From: Claire Williams [clwilliams@kctmo.org.uk]
Sent: 31/10/2013 10:23:47
To: Bruce Sounes [/O=STUDIO E/OU=EXCHANGE ADMINISTRATIVE GROUP (FYDIBOHF23SPDLT)/CN=RECIPIENTS/CN=Bruce]; d.campbell@maxfordham.com; M.Smith@maxfordham.com
CC: Grenfell [/O=STUDIO E/OU=First Administrative Group/cn=Recipients/cn=Grenfell]; BOOTH Philip [philip.booth@uk.arteliagroup.com]; Chweecheen Lim [Chweecheen.Lim@appleyards.co.uk]
Subject: RE: Grenfell - overcladding VE?

From: Bruce Sounes [mailto:bruce@studioe.co.uk]
Sent: 29 October 2013 19:39
To: d.campbell@maxfordham.com; M.Smith@maxfordham.com; Claire Williams
Cc: Grenfell; BOOTH Philip; Chweecheen Lim
Subject: Grenfell - overcladding VE?

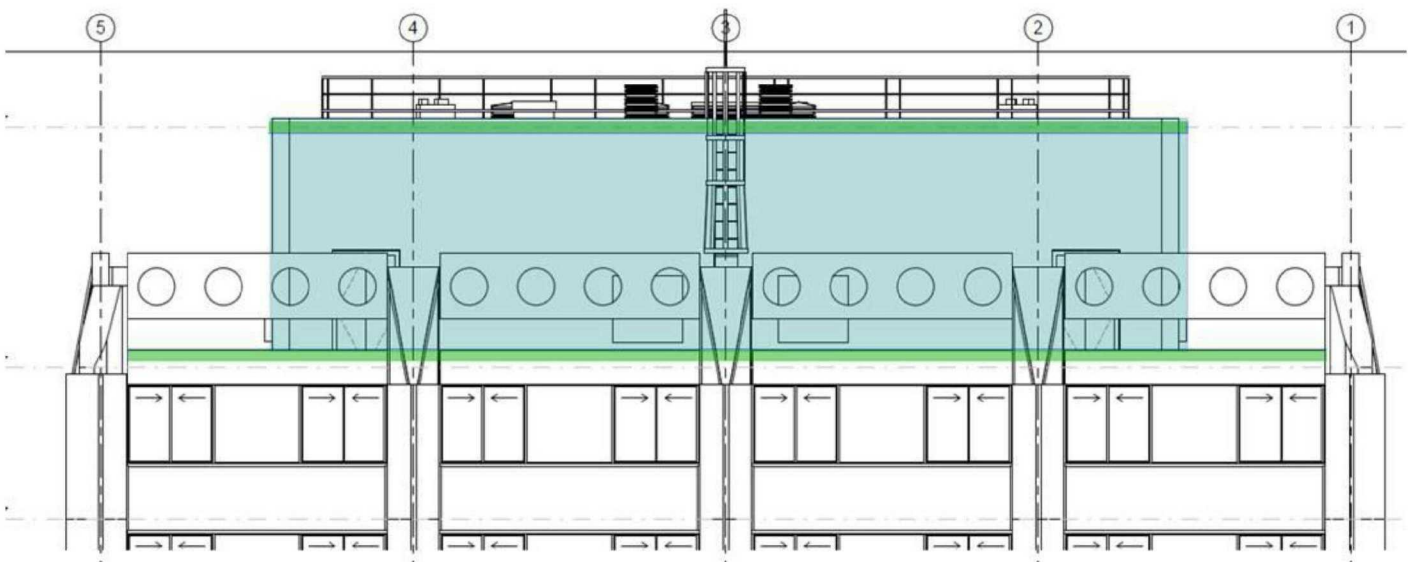
On a much smaller refurbishment project with Max Fordham recently we have successfully argued the case with Building Control for not upgrading areas of roof/wall that are not touched by the refurbishment. As I understand Part L we only need to upgrade the thermal performance of a part which is to be replaced. Eg a roof membrane/window etc.

The existing roof membranes look relatively new (and we think there is some insulation under them) and we have no need to upgrade/re-finish the plant room enclosure. The markup below indicates the area I'm referring to. This would simplify the work and contribute some big savings.

Please could you comment?

- 1 Upgrading of existing roof and tank room areas: Chweecheen, perhaps we can make this work all provisional – so we get prices but keep our options open. I do not know if the mast climbers need to be attached to the roof and this may cause damage, but in which case we get the areas 'condition surveyed' beforehand. But I agree; this is a good area of potential saving.
- 2 Fire strategy and building control: Bruce can you make this easy for me, and give me direct tel nos and any references etc. Also you need to do me a bullet point prompt on the specific areas so I mention all the issues. (3 days of holiday)
